HISTORIC AND DESIGN REVIEW COMMISSION

November 17, 2021

HDRC CASE NO: 2021-508
ADDRESS: 275 NORTH DR
LEGAL DESCRIPTION: NCB 6708 BLK 18 LOT 18 & W 25 FT OF 17
ZONING: R-6
CITY COUNCIL DIST.: 7
DISTRICT: Monticello Park Historic District
APPLICANT: Eugene Davis
OWNER: Eugene Davis
TYPE OF WORK: Addition of a curb cut
APPLICATION RECEIVED: September 30, 2021
60-DAY REVIEW: Not applicable due to City Council Emergency Orders
CASE MANAGER: Katie Totman
REQUEST:

The applicant is requesting a Certificate of Appropriateness for approval to add a curb cut to an existing bricked area in front of a rear yard gate.

Curb
cut

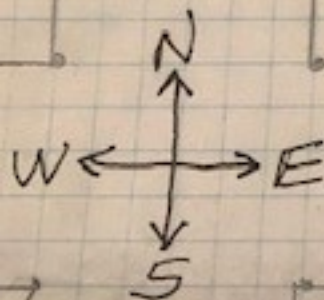
c. PROPOSED CURB CUT – Following the Design Review Committee (DRC) site visit, the applicant is requesting to add a curb cut to the existing bricked area in front of the driveway gates fronting Shearer Blvd. The applicant is proposing to create a curb cut to be no wider than approximately 17-feet, which is the width of the opening of the gates. Staff finds that this is appropriate given that the bricked area currently exists. Additionally, staff finds that the proposed curb cut should not exceed the width of the existing curb cut and should match in profile regarding the tapering of the curb.

Staff recommends approval of the proposed curb cut based on findings b and c. Additionally, staff finds that the proposed curb cut should not exceed the width of the existing curb cut and should match in profile regarding the tapering of the curb.
